ARKANSAS NUCLEAR ONE, UNIT 2

AMENDMENT TO FACILITY OPERATING LICENSE

Amendment No. 82
License No. NPF-6

ATTACHMENT TO LICENSE AMENDMENT NO. 82

FIGURE 3.1-1

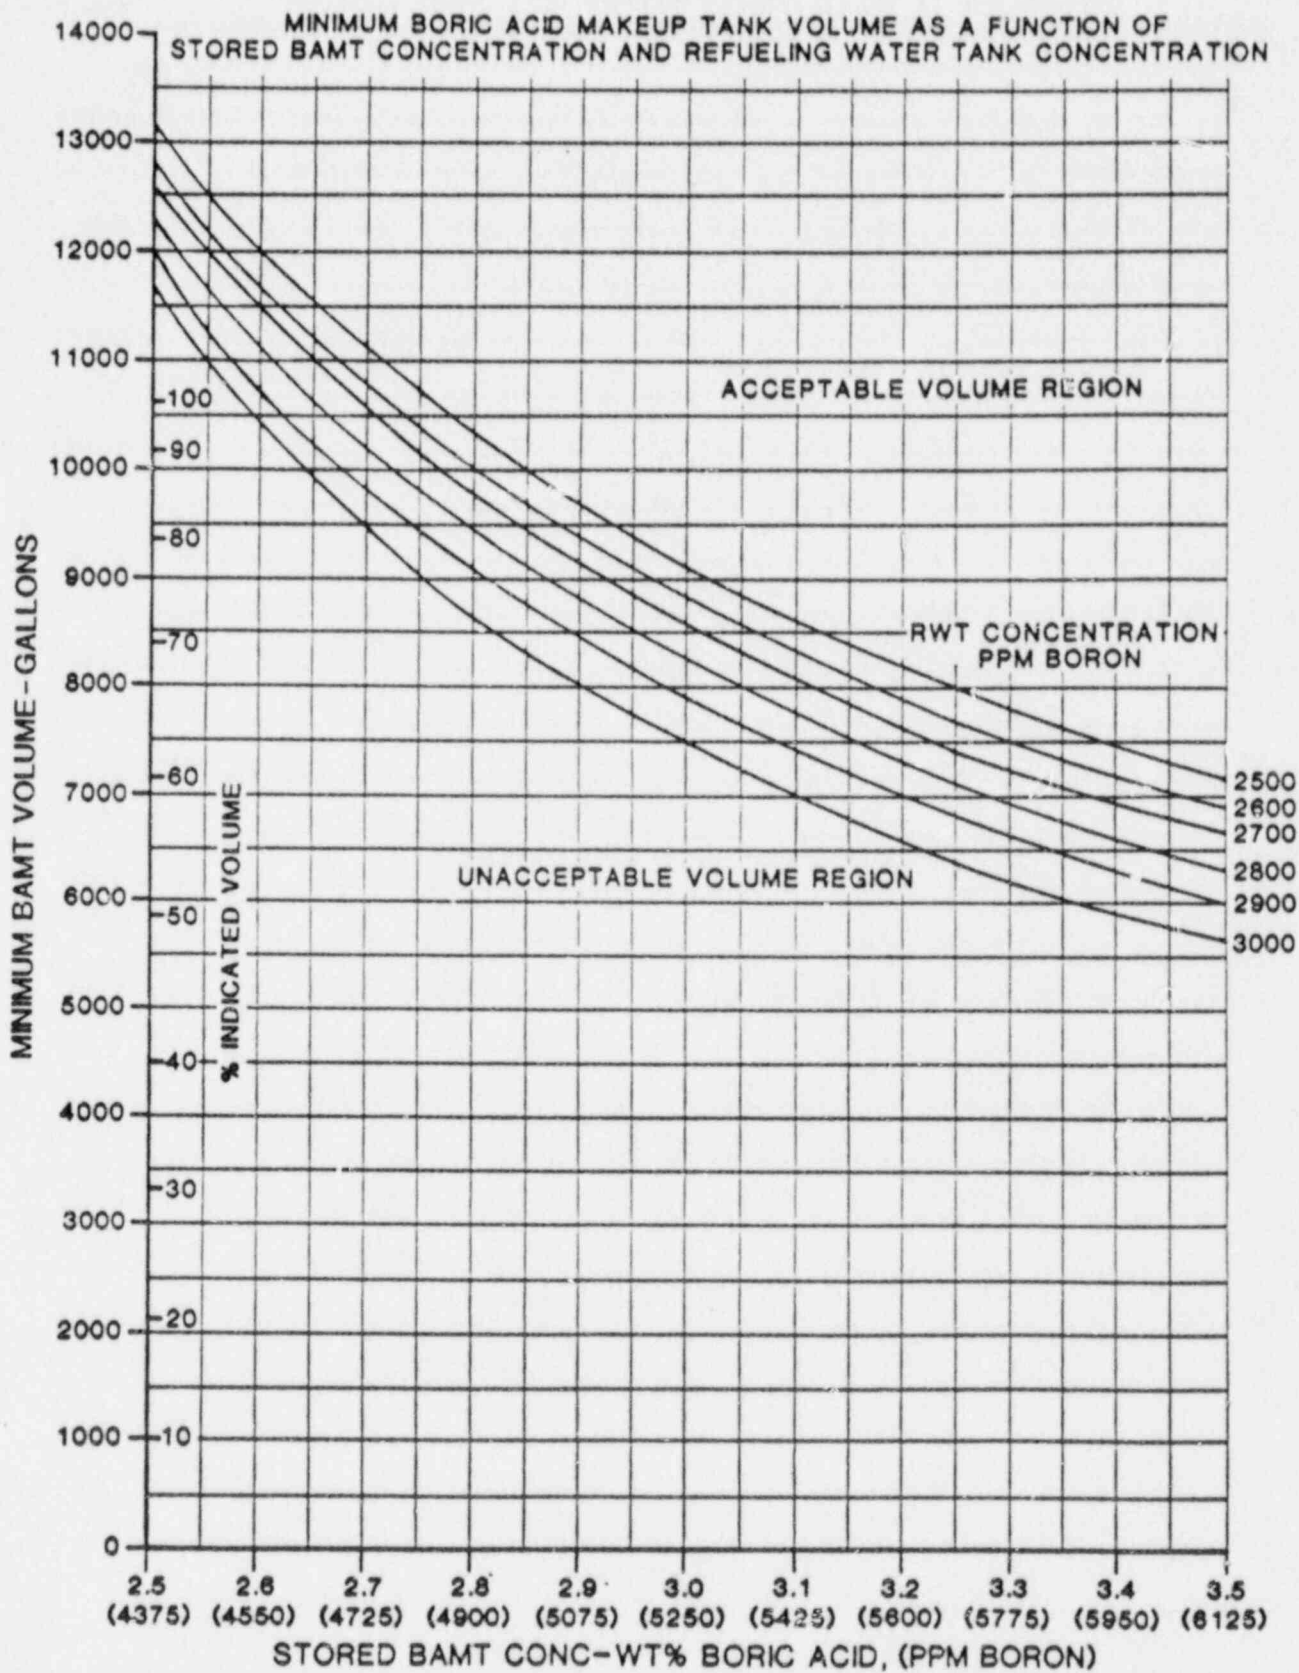
- 3.1.2.2 The following boron injection flow paths shall be OPERABLE, depending on the volume available in the boric acid makeup tanks.
- a. If the contents of ONE boric acid makeup tank meet the volume requirements of Figure 3.1-1, two of the following three flow paths to the Reactor Coolant System shall be OPERABLE:

3. One flow path from the refueling water tank via a charging pump.
- OR
- b. If the contents of BOTH boric acid makeup tanks are needed to meet the volume requirements of Figure 3.1-1, four of the following five flow paths to the Reactor Coolant System shall be OPERABLE:

- a. At least one of the following sources with a minimum solution temperature of 55°F:
 1. One boric acid makeup tank, with the tank contents in accordance with Figure 3.1-1, or
 2. Two boric makeup tanks, with the combined contents of the tanks in accordance with Figure 3.1-1, and
- b. The refueling water tank with:
 1. A contained borated water volume of between 464,900 and 500,500 gallons (equivalent to an indicated tank level of between 91.7% and 100%, respectively),
 2. Between 2500 and 3000 ppm of boron,
 3. A minimum solution temperature of 40°F, and
 4. A maximum solution temperature of 110°F.
